**Section 75W Modification Requests
Bungarribee Industrial Estate, Huntingwood West Precinct
Concept Plan MP06_0203 MOD2
Stage 1 Infrastructure Works Project Approval MP08_0225 MOD1**

Director-General's
Environmental Assessment Report
Section 75W of the
Environmental Planning and Assessment Act 1979

February 2013

Figure 7: Proposed plan of subdivision

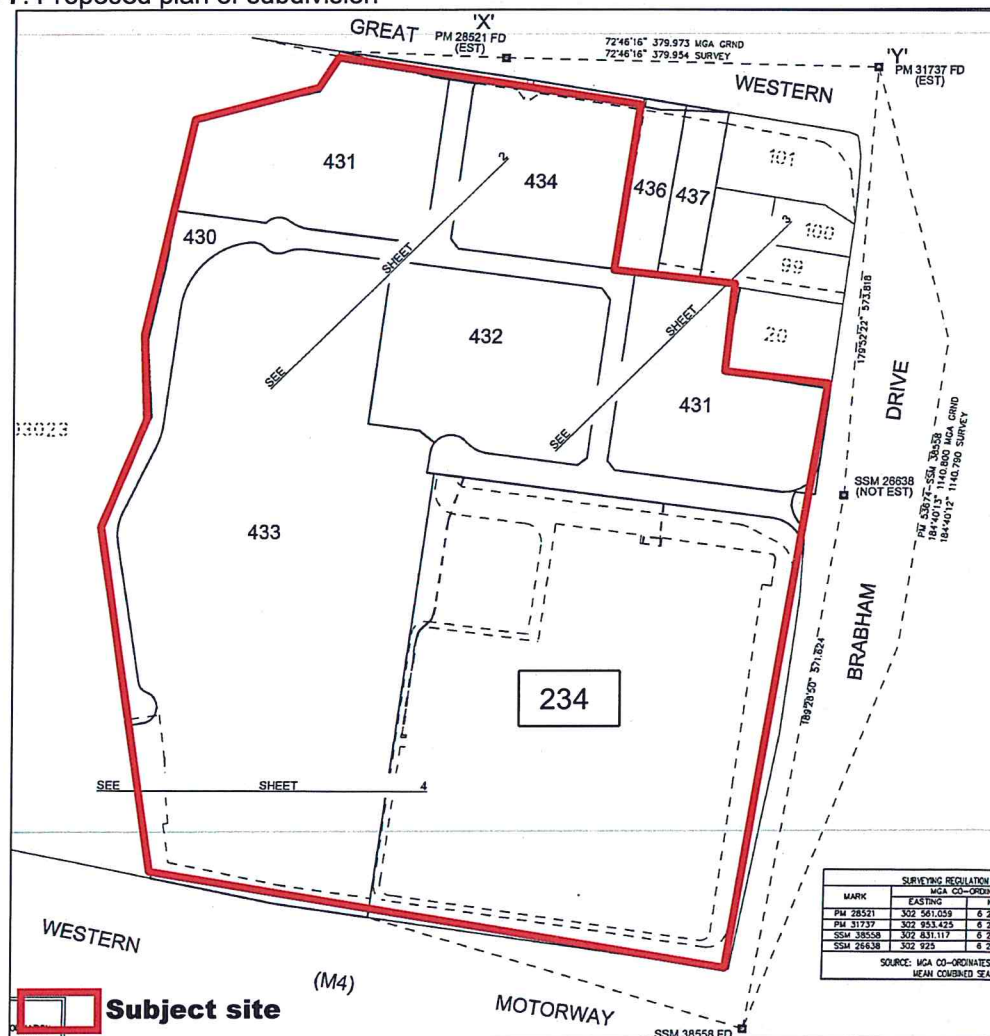
The proposed site layout shown in **Figure 6** is sought as is an amended plan of subdivision to be consistent with the site layout. The proposed plan of subdivision is shown in **Figure 7**.

The proponent is also seeking to amend the subdivision plan for the site. Subdivision has been approved under MP08_0055 and MP08_0225. The subdivision plan submitted as part of this modification request will be consistent with the revised site layout proposed and will require the proponent to surrender the subdivision approval under MP08_0055. A condition is proposed to the amended project approval to address this matter. The

proponent has agreed to this condition as the subdivision layout approved under MP08_0055 is now redundant. Subdivision approval will now be wholly under MP08_0225.
